**ADDENDUM NO. 1 TO PROJECT NO. 44187**

**CONSTRUCTION WORK, HVAC WORK AND ELECTRICAL WORK**

**PROVIDE VENTILATION, MAIN SCHOOL BUILDING  
VARIOUS DOCCS FACILITIES**

March 12, 2013

## DDC CONTROL BLOCK DIAGRAM

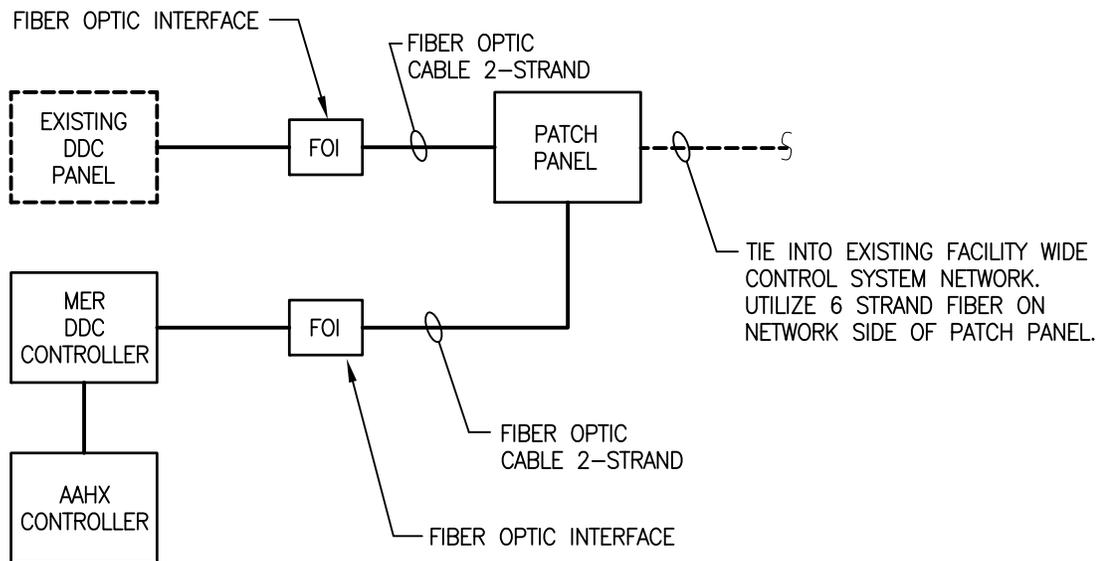
1. Revised Drawing:
  - a. Drawing No. M-001, noted “REVISED DRAWING 3/6/13” ACCOMPANIES THIS Addendum and supersedes the same numbered originally issued drawing.
2. Addendum Drawing
  - a. Drawing SK-1H, noted “DDC CONTROL BLOCK DIAGRAM” accompanies this Addendum and forms part of the Contract Documents.
3. Revised Detail Drawing:

1 ENLARGED M.E.R. 4  
 M-101 SCALE : 1/4" = 1'-0"

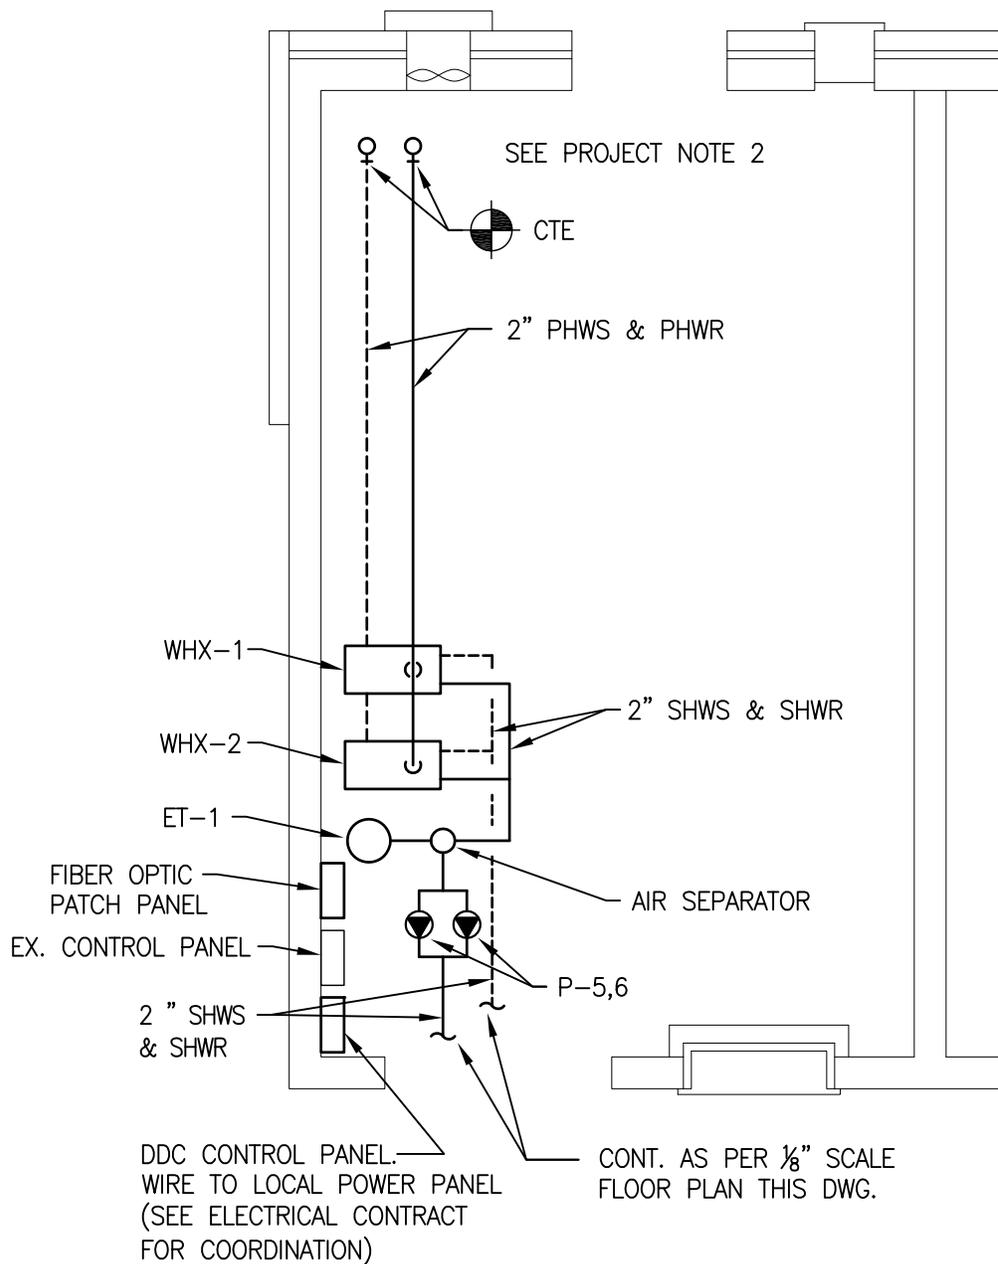
- a. Drawing No. SK-2H, noted "ENLARGED M.E.R. 4" and dated 3/1/13 replaces detail 1/M-101 on originally issued drawing M-101.
4. Revised Detail Drawing:
  - b. Drawing No. SK-3H, noted "ENLARGED M.E.R. 4" and dated 3/1/13 replaces detail 1/M-102 on originally issued drawing M-102.
5. Revised Detail Drawing:
  - c. Drawing No. SK-4H, noted "ENLARGED M.E.R. 14" and dated 3/1/13 replaces detail 1/M-103 on originally issued drawing M-103.
6. Revised Detail Drawing:
  - d. Drawing No. SK-5H, noted "ENLARGED M.E.R. 14" and dated 3/1/13 replaces detail 1/M-104 on originally issued drawing M-104.

DWG NO:  
 E-113

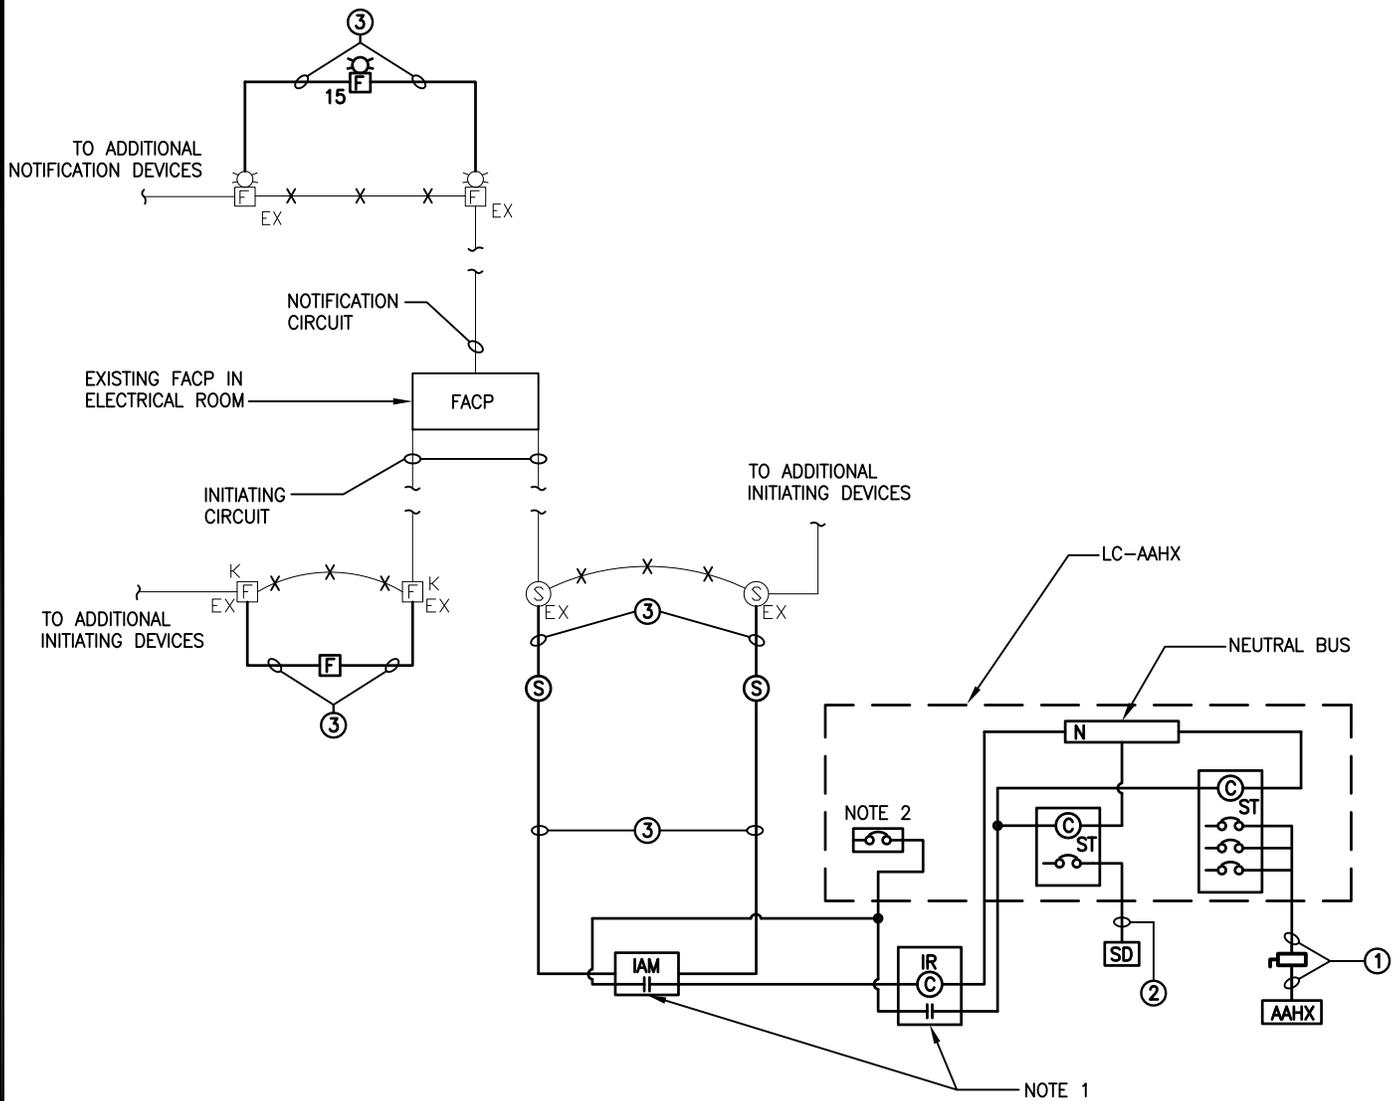
3. E-106:
  - a. "FIRE ALARM ONE-LINE – LIVINGSTON CF BLDG. NO. 4"
    - Replace detail with detail on drawing E-113, noted "REVISED DETAIL FIRE ALARM ONE-LINE 3/6/2013".

- Replace detail with detail on drawing E-113, noted "REVISED DETAIL FIRE ALARM ONE-LINE 3/6/2013".

- a. E-113:
  - Drawing E-113, noted “REVISED DETAIL FIRE ALARM ONE-LINE 3/6/2013” accompanies this addendum and forms part of the Contract Documents.

DWG NO:  
 E-114

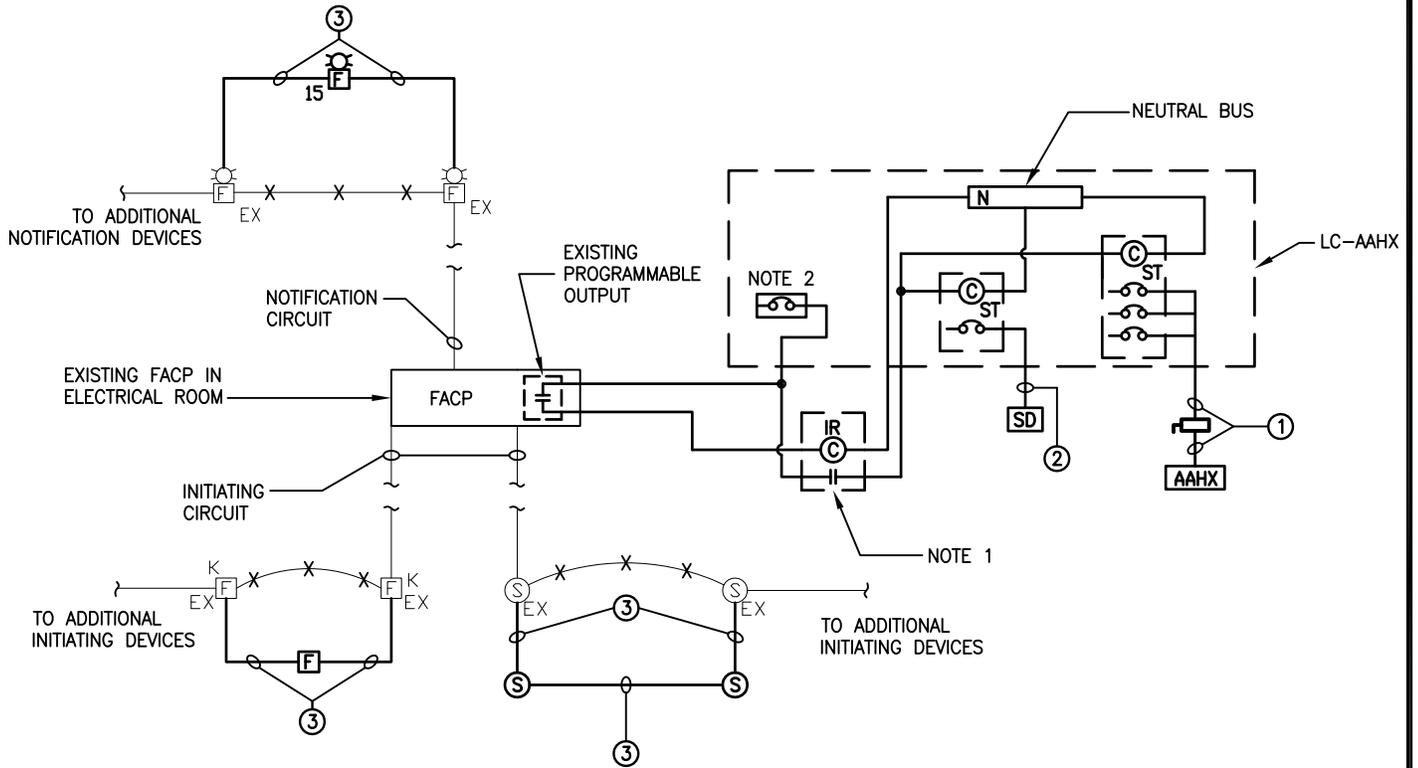
- Remove symbol for Individual Addressable Module, IAM.
  - b. "FIRE ALARM ONE-LINE – LAKEVIEW CF BLDG. NO. 4"
    - Replace detail with detail on drawing E-114, noted "REVISED DETAIL FIRE ALARM ONE-LINE LAKEVIEW CF AND ORLEANS CF 3/6/2013".

- Replace detail with detail on drawing E-114, noted "REVISED DETAIL FIRE ALARM ONE-LINE LAKEVIEW CF AND ORLEANS CF 3/6/2013".
5. E-112:
  - a. "FIRE ALARM ONE-LINE – WYOMING CF BLDG. NO. 14"

- b. E-114:
  - Drawing E-114, noted “REVISED DETAIL FIRE ALARM ONE-LINE LAKEVIEW CF AND ORLEANS CF 3/6/2013” accompanies this addendum and forms part of the Contract Documents.
